Sept. 9th Pre-Application Review

SUMMARY MINUTES OF THE HERITAGE PRESERVATION COMMISSION
CITY OF SAINT PAUL, MINNESOTA
Lower Level – Room 41, City Hall/Court House, 15 West Kellogg Boulevard
September 9, 2010

FILE NAME: 255 Sixth Street East
DATE OF APPLICATION: August 20, 2010
APPLICANT: Gleeson Architects, Dan Gleeson
OWNER: 9 and 19 Properties, LLC, Dave Brooks
DATE OF PRE-APPLICATION: September 9, 2010
HPC SITE/DISTRICT: Lowertown Historic District
CATEGORY: Non-Contributing
CLASSIFICATION: Building
STAFF INVESTIGATION AND REPORT: Amy Spong
DATE: September 2, 2010

During painting phase - shows signs removed

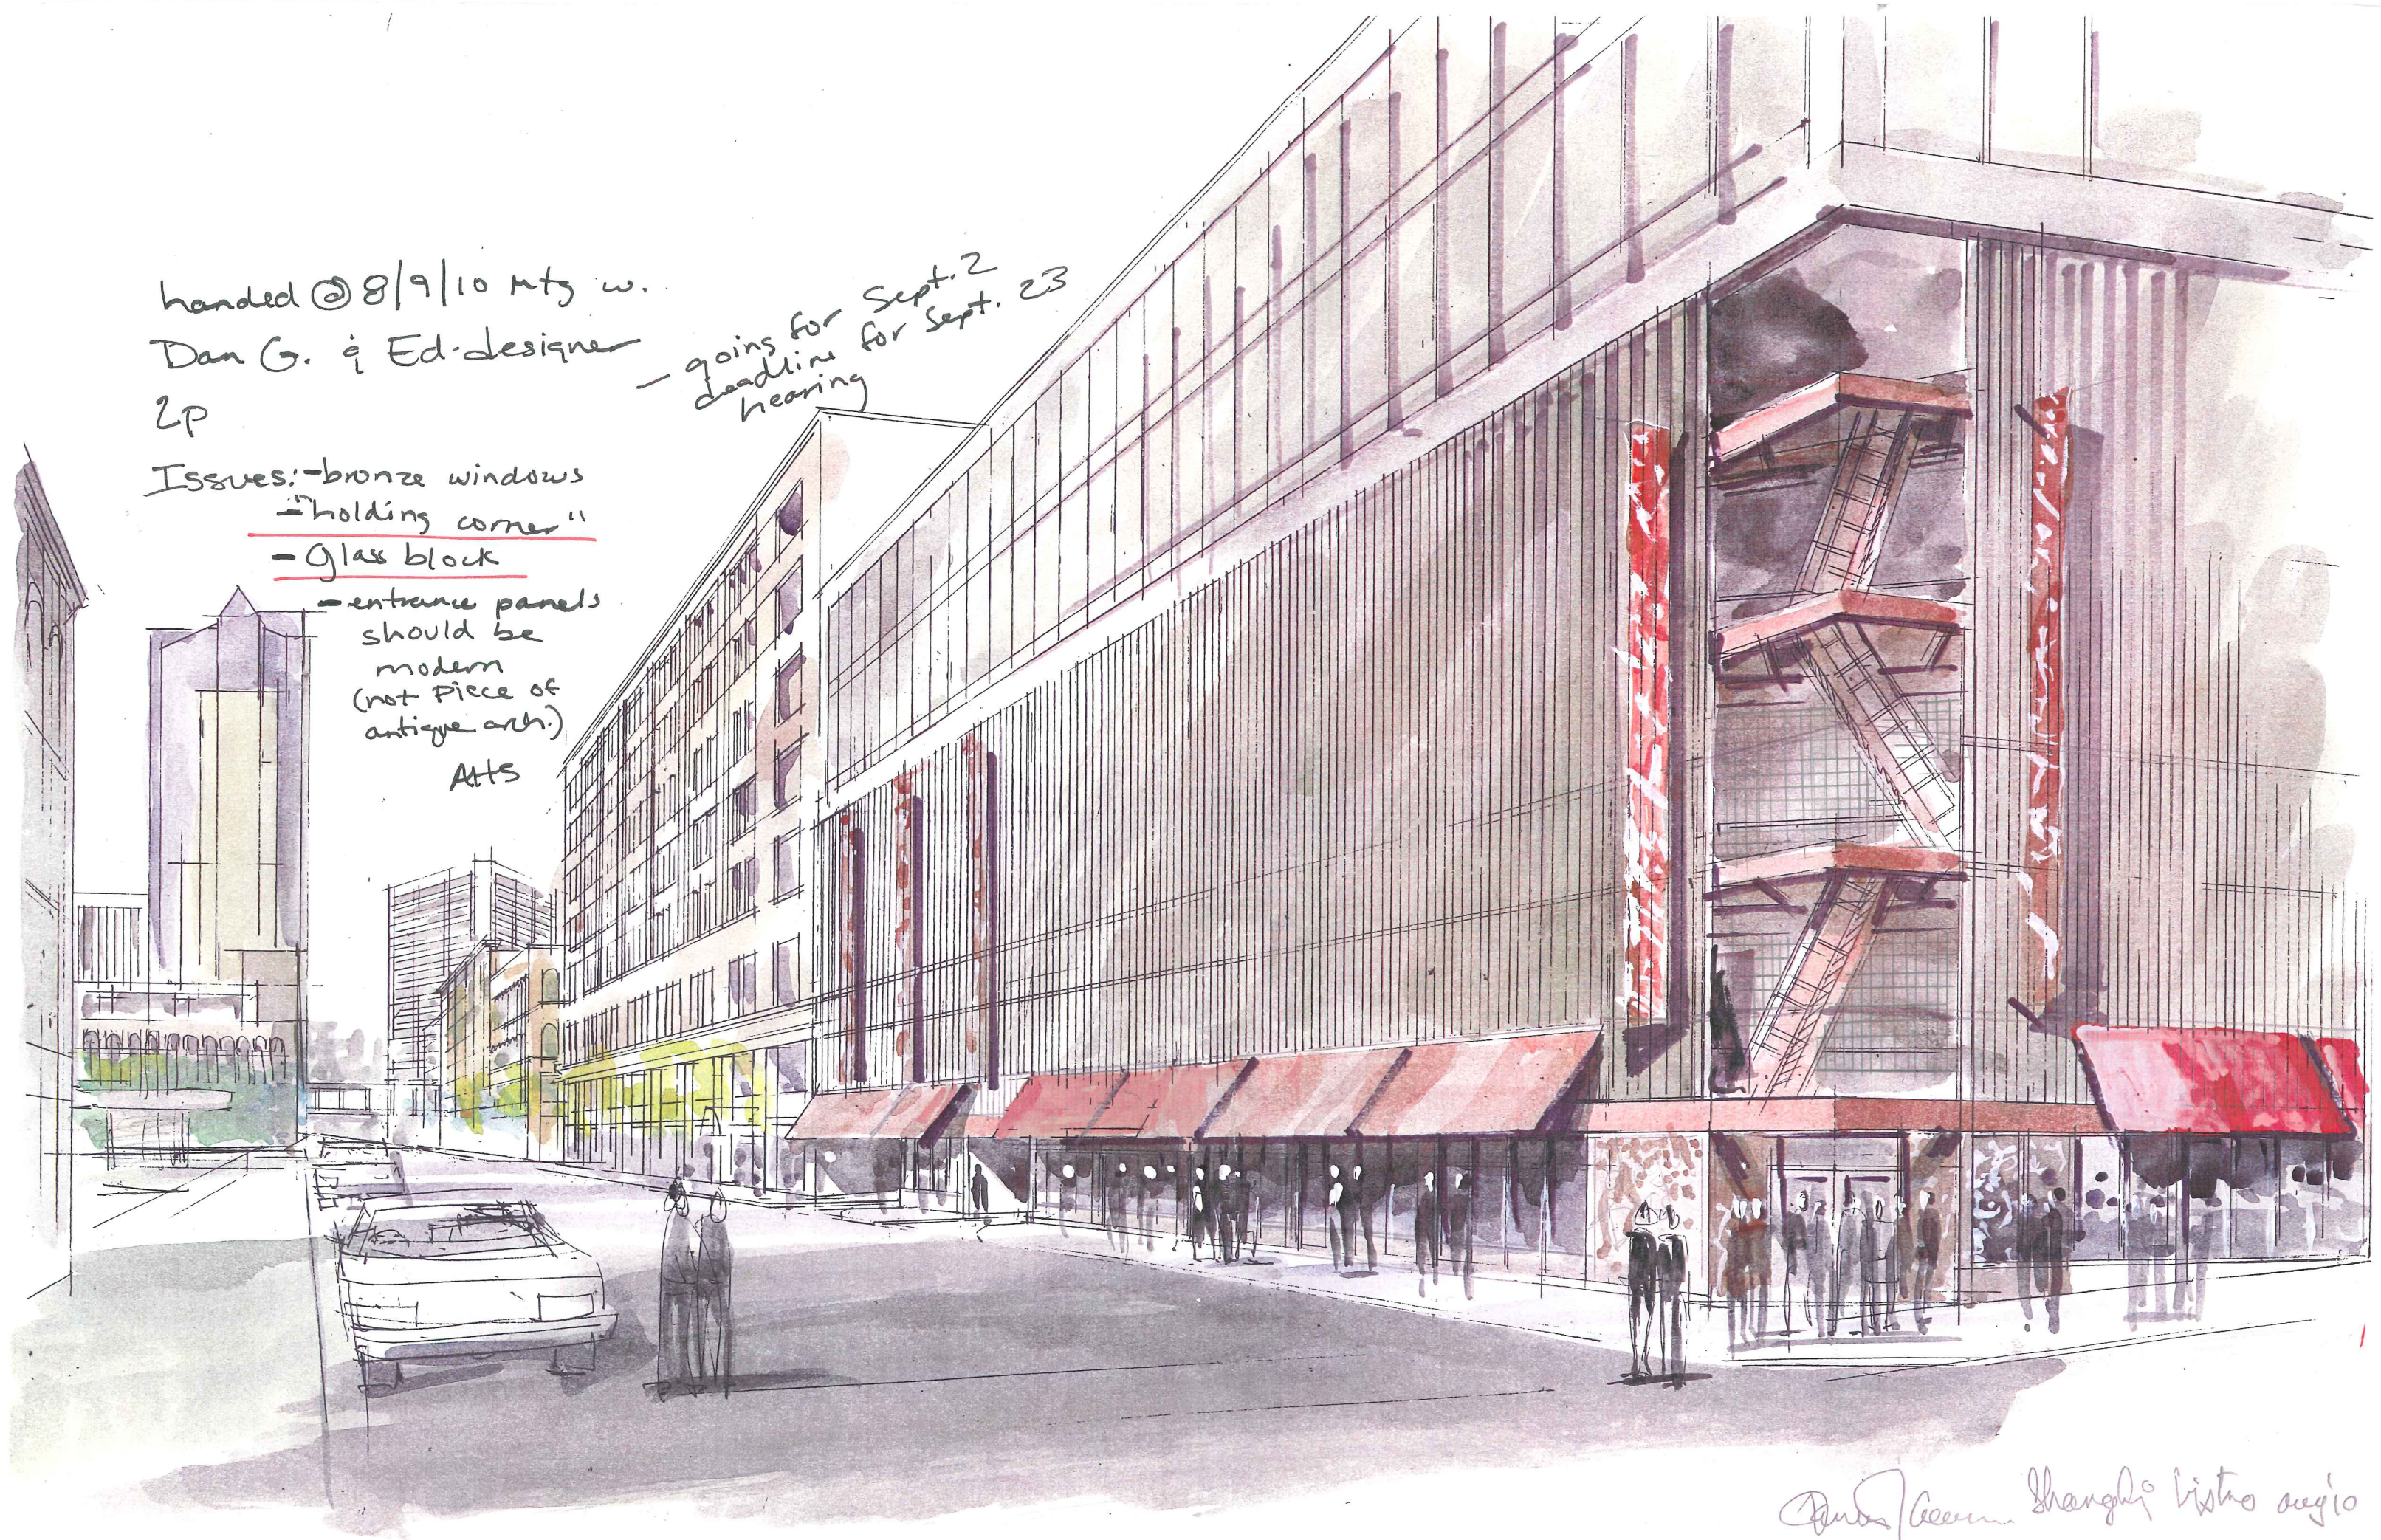
* Shows removal
of corner fins and
red paint which
were done w/o
HPL review and
approval.

- Issues: - bronze windows
- "holding corner"
- Glass block
- entrance panels
should be
modern
(not piece of
antique arch.)
AttS
